**ADDENDUM TO
REQUEST FOR PROPOSALS
ALTADENA MAIN LIBRARY
RENOVATION PROJECT
Altadena Library District**

ADDENDUM NO. 4

DATE: September 19, 2025

A. Sheet L301 – Soil Management Plan:

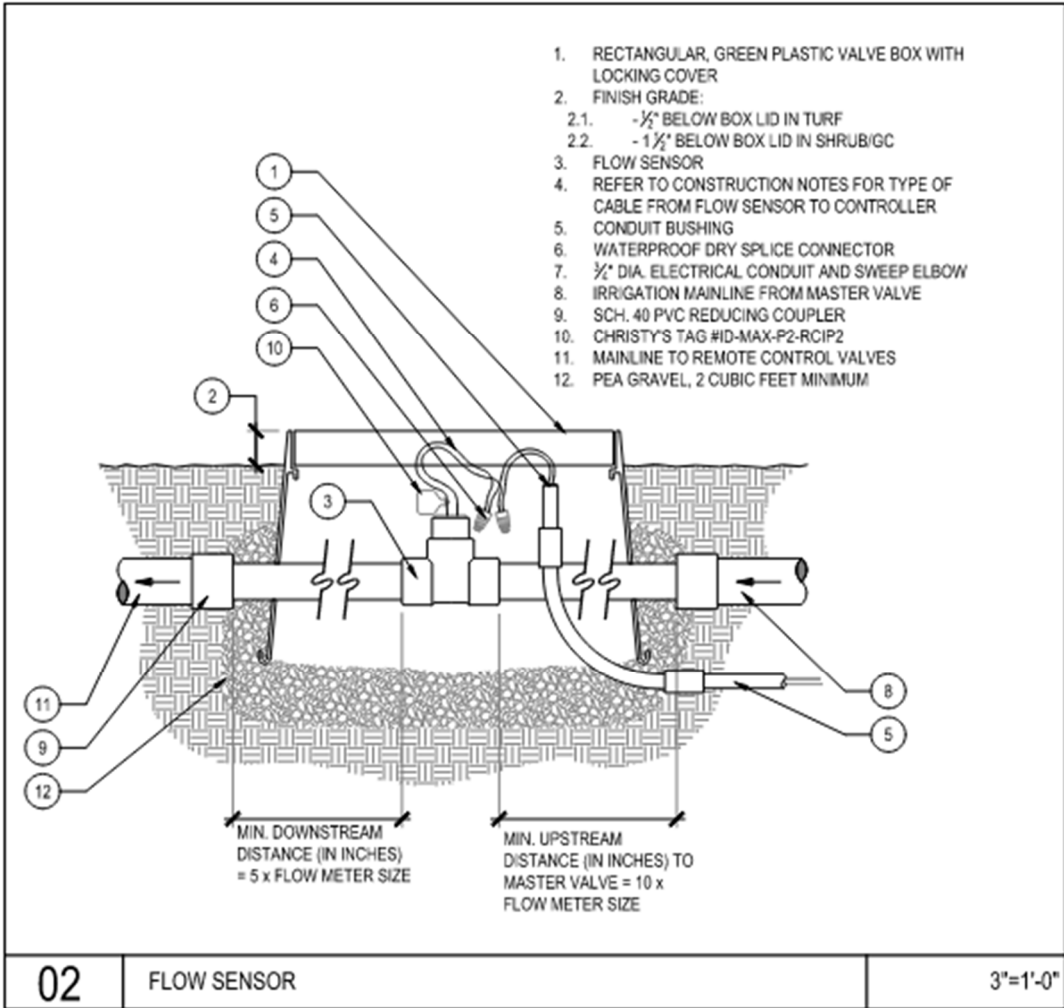
- 1. **Add** L301 to drawings.

- 3. There is no sheet L301 - Soil Management Plan as listed in the Landscape Sheet Index on sheet L000 - Landscape Title Sheet. Please clarify.
 - a. **Response: Sheet L301 should be included in the bid set and is attached to this addendum.**

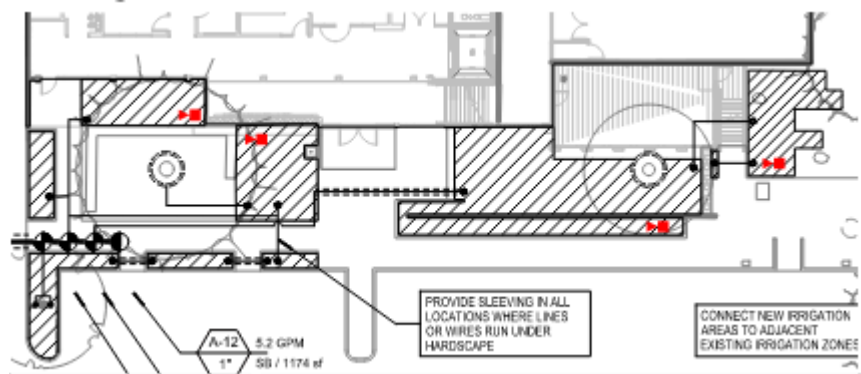
a. Response: Defer to lowest distance- 4 inches.
10. Refer to detail 3 on sheet L210, call out no.5 shows about flow sensor cable and conduit. However, there is no new flow sensor in this project as it is not shown on plan or legend on sheet L200. Please confirm there is no flow sensor required for this project.

a. Response: Please provide a flow sensor immediately after the Master Valve: Hunter Flow-Click Flow Sensor in Rainbird VBSTD box, hardwired to controller via shielded min. 18 AWG wire. See attached detail.
